Immingham Green Energy Terminal

TR030008

9.65 Report on traffic matters related to IGET for
National Highways

1 Relevant Representation Response

Client:	Project:	Title:	AECOMI	Number:	Rev
	IGET	IGET CONSTRUCTION HGV 0700 to 0800 1600 to 1700		FIGURE 3

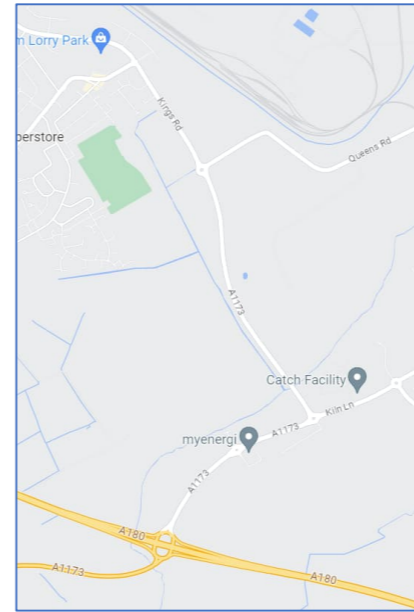
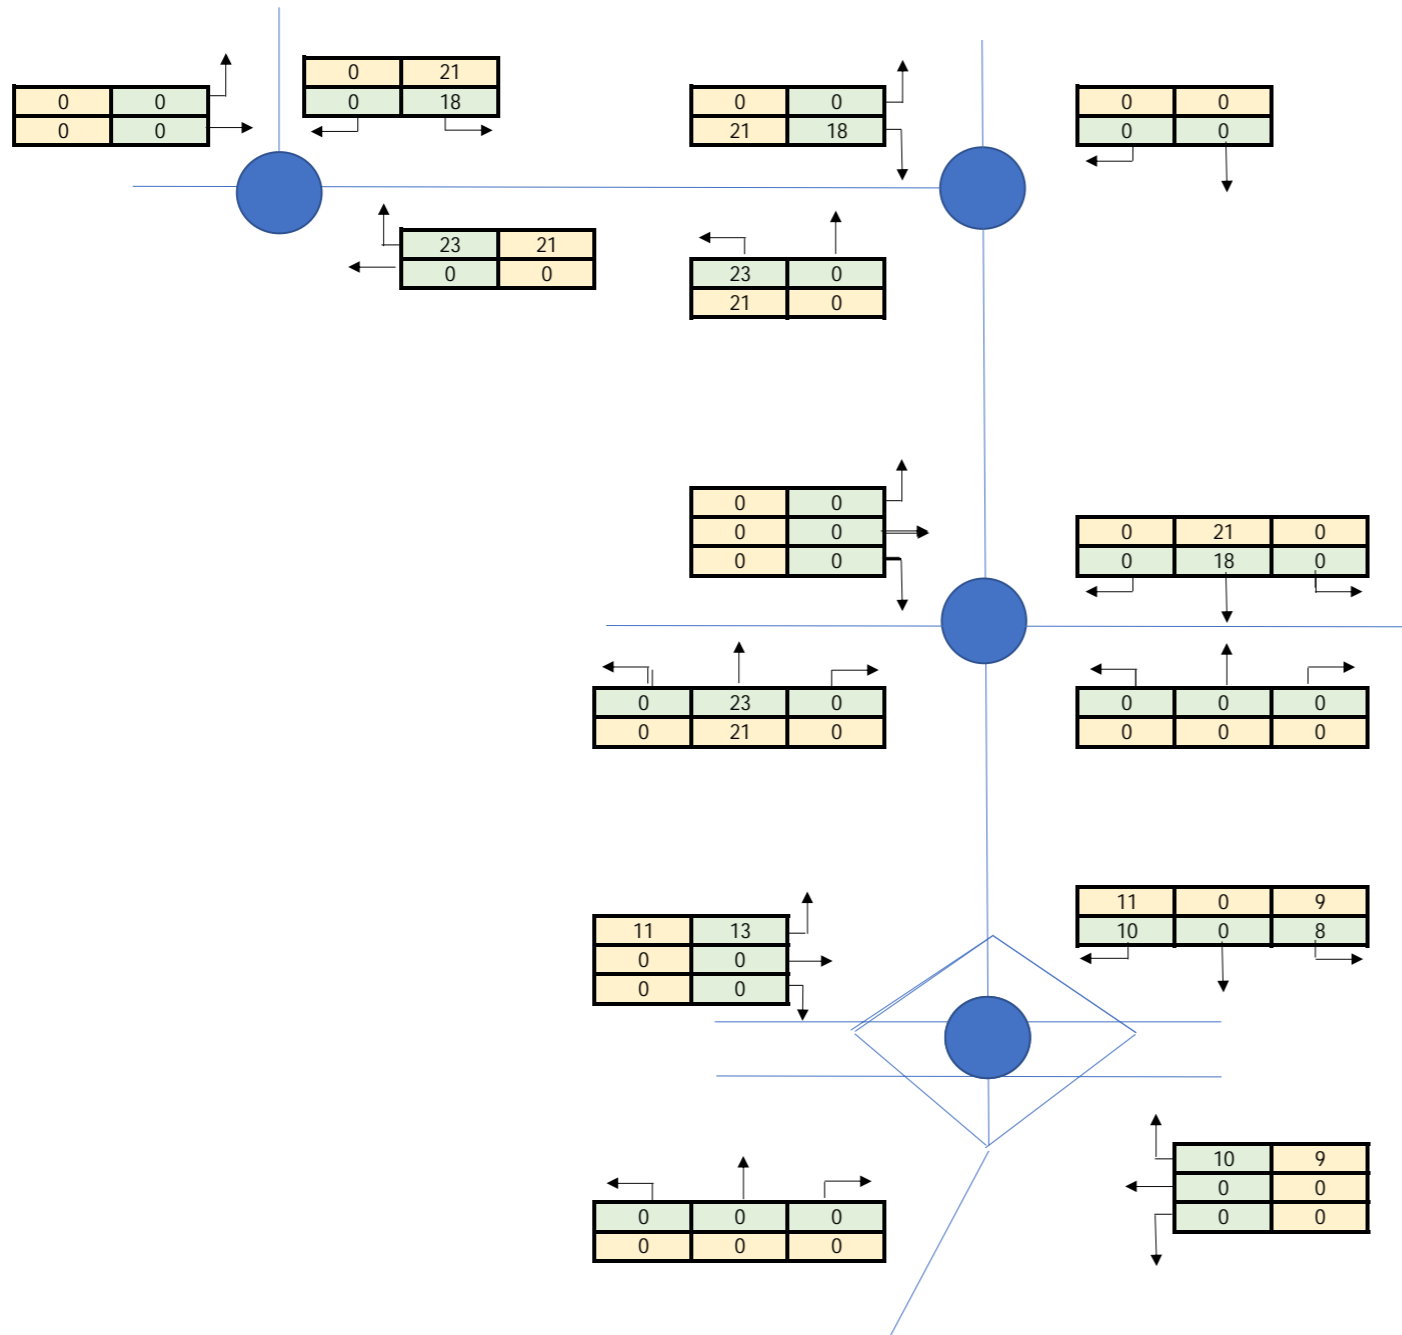
- 1.13 Base 2026 + Committed Development + IERRT + the Project (07:00–0800 and 16:00–17:00)
- 1.13.1 The PROJECT construction traffic flows have been taken from ES Chapter 11: Traffic and Transport [[APP-053](#)] with the daily profile of construction workers being shown in Table 11-13 and the HGV profile shown in Table 11-14. Key figures are:

- Construction workers – 190 arrivals and 15 departures between 07:00 and 08:00 and 15 arrivals and 38 departures between 16:00 and 17:00.
 - Construction HGVs – 10 arrivals and eight departures between 07:00 and 08:00 and nine arrivals and nine departures between 16:00 and 17:00.

- 1.13.2 This is illustrated on **Figures 2 and 3** within **Appendix 4** of this Relevant Representation Response.
- 1.14 Base 2026 + Committed Development + IERRT + the Project (Sensitivity Test, Project construction traffic between 06:00 and 07:00 and between 18:00 and 19:00)

Client:	Project:	Title:	AECOMI	Drawing Number:	Rev
	IGET	IGET CONSTRUCTION 0700 to 0800 1600 to 1700		FIGURE 2

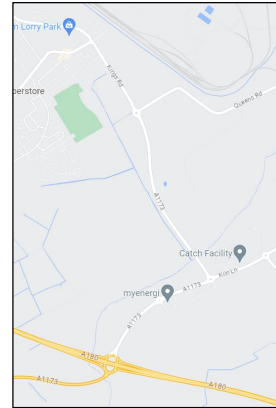
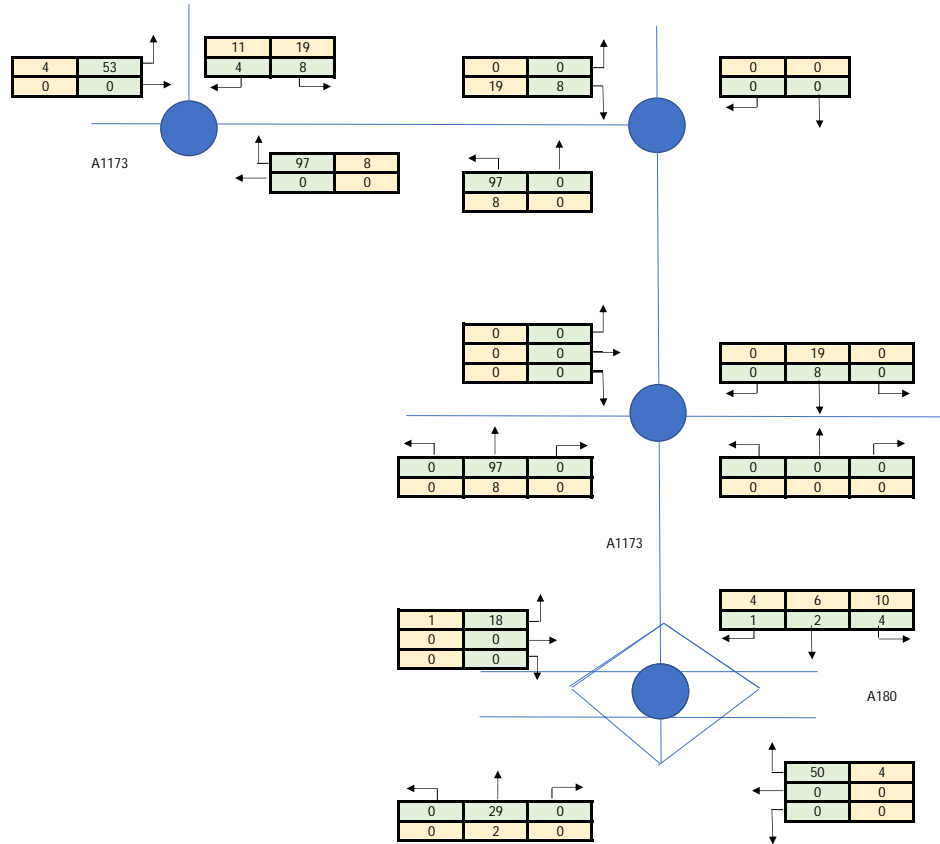
1.4.2 National Highways considers that the weekday peak hours periods should be 07:00–08:00 and 16:00–17:00 rather than 08:00–09:00 and 17:00–18:00 as set out in **Paragraph 11.8.17 in ES Chapter 11: Traffic and Transport [APP-053]** which states “*during the weekday AM peak, 08:00 to 09:00 there is anticipated to be 53 worker trips and during the weekday PM peak 17:00 to 18:00 there is anticipated to be 137 worker trips on the road network*”.

Client:	Project:	Title:	AECOMI	Number:	Rev
	IGET	IGET CONSTRUCTION HGV 0600 to 0700 1800 to 1900		FIGURE 4

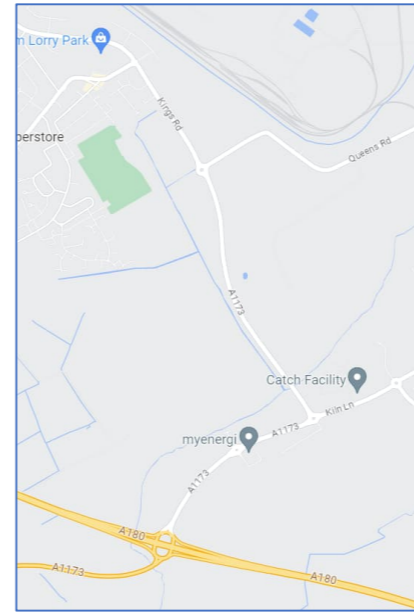
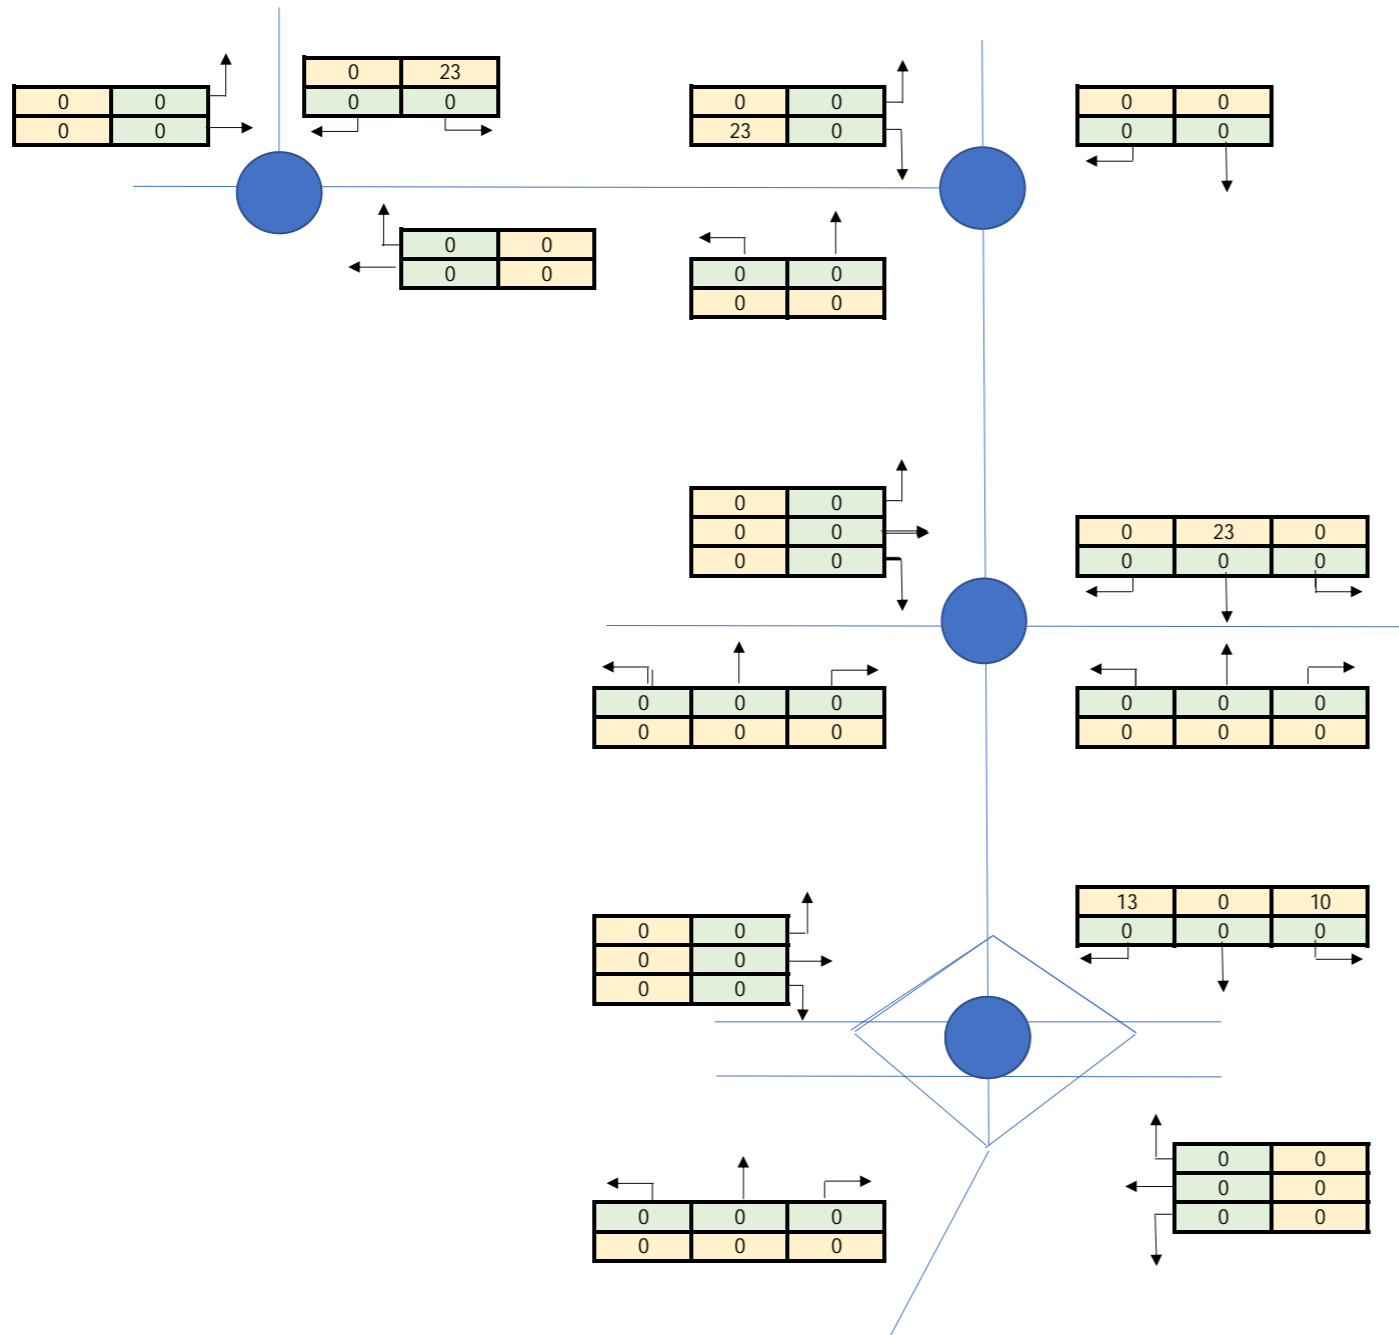
- 1.14.1 The PROJECT construction traffic flows have been taken from ES Chapter 11: Traffic and Transport [[APP-053](#)] with the daily profile of construction workers being shown in Table 11-13 and the HGV profile shown in Table 11-14. Key figures are:

- Construction workers – 258 arrivals and 15 departures between 06:00 and 07:00 and 23 arrivals and 266 departures between 18:00 and 19:00.
 - Construction HGVs – zero arrivals and zero departures between 06:00 and 07:00 and zero arrivals and 10 departures between 18:00 and 19:00.

- 1.14.2 This is illustrated on **Figures 1 and 4** within **Appendix 5** of this Relevant Representation Response.
- 1.14.3 As National Highways has not specifically commented on the above in its response of 12 March 2024, it is understood that this element is agreed.
